SUBJECT: Lewis University Airport
Romeoville, Illinois
Will County
Illinois Project Number: LOT-5151
Contract No. LE057
Item No. 07A, January 17, 2025, Letting
Addendum A

NOTICE TO PROSPECTIVE BIDDERS

DRAWING TITLE
ELECTRICAL AND LIGHTING DETAILS - 2

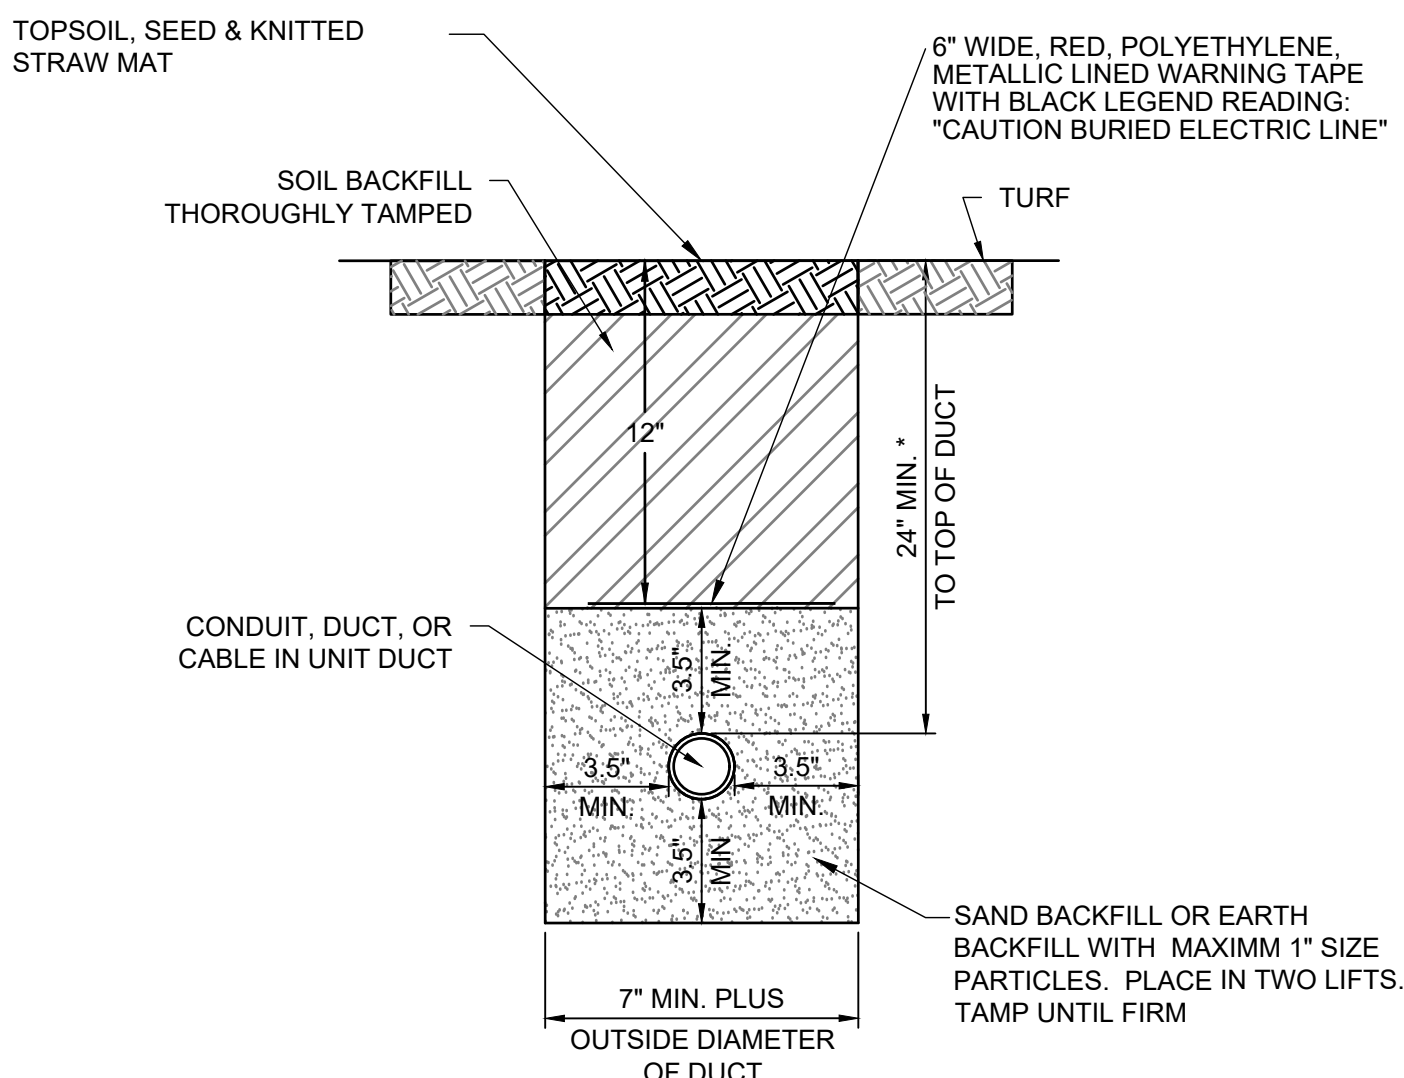
- 1) Clarifies rebar to be inserted in ends of Concrete Encased 4-Way, 2" PVC Duct.

- 1) Sheet 25 Electrical and Lighting Details -2

1. DIMENSIONS FOR COVERAGE AND SEPARATION BETWEEN DUCTS ARE MINIMUM.
2. INCLUDE DUCT SPACERS TO MAINTAIN PROPER SEPARATION OF CONDUITS.
3. REBAR IS REQUIRED TO ACCOMMODATE FUTURE DUCT EXTESIONS AND INTERFACE AT DUCT BANK TERINATIONS. CONCRETE ENCASED DUCT BANKS TERMINATING IN HANDHOLES REQUIRE REBAR AT TERMINATIONS.
4. CONDUITS FOR CONCRETE ENCASED DUCT SHALL BE SCHEDULE 40 PVC.
5. MINIMUM DEPTH OF TOP OF DUCT ENCASEMENT SHALL BE 18" BELOW FINISHED GRADE.
6. HIGH VOLTAGE AND LOW VOLTAGE CIRCUITS SHALL NOT BE INSTALLED IN THE SAME RACEWAY, CONDUIT, DUCT, HANDHOLE, OR MANHOLE.
7. DUCT INTERFACE TO HANDHOLES OR MANHOLES WILL BE CONSIDERED INCIDENTAL TO THE DUCT.
